Amendments to the Drawings:

Attachment: Replacement sheets for Figures 1, 2, 3A, 3B, 3C, 3D, 4A, 4B, 5A, 5B, 6, and 7.

FIG. 3A

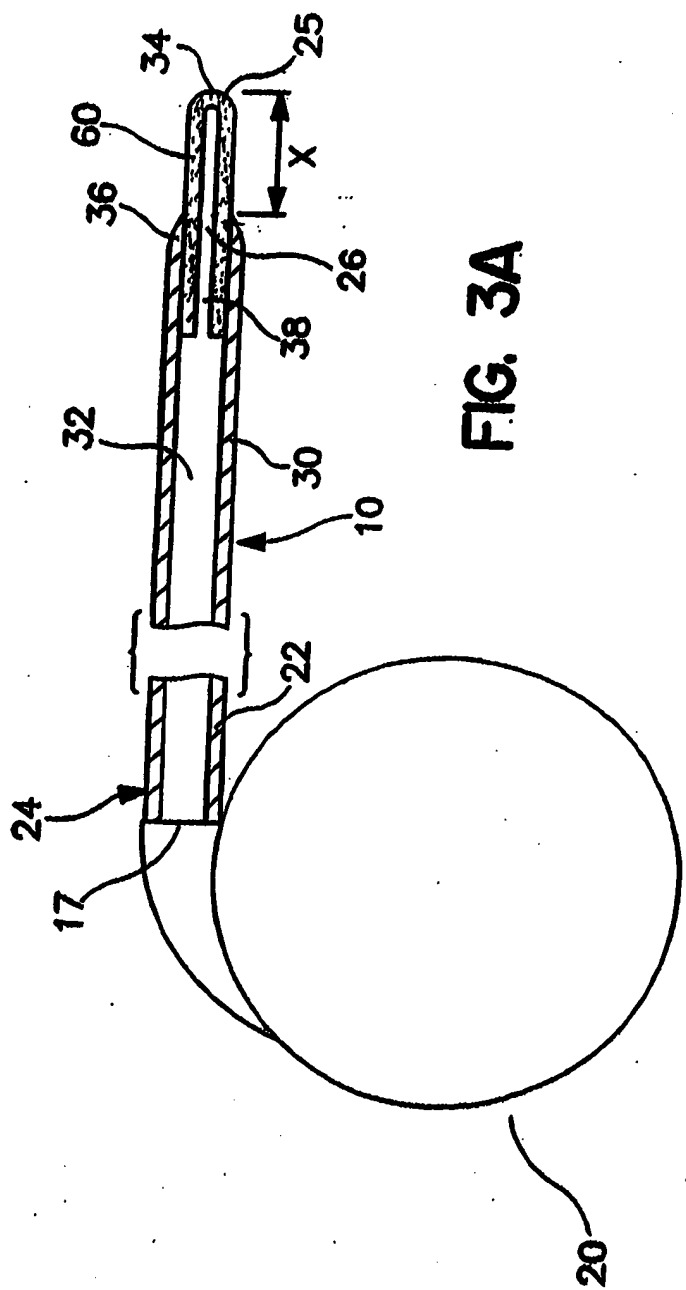
The attached sheets of formal drawings replace original informal drawings for Figures 1 through 7. The attached sheets of formal drawings include changes to Figures 3A, 3D, 4B and 5B. The changes correctly identify lumen 38 and delete all references to the number "18" since the number 18 is not used to identify any element in the specification. Also device 20 is identified in these figures where appropriate.
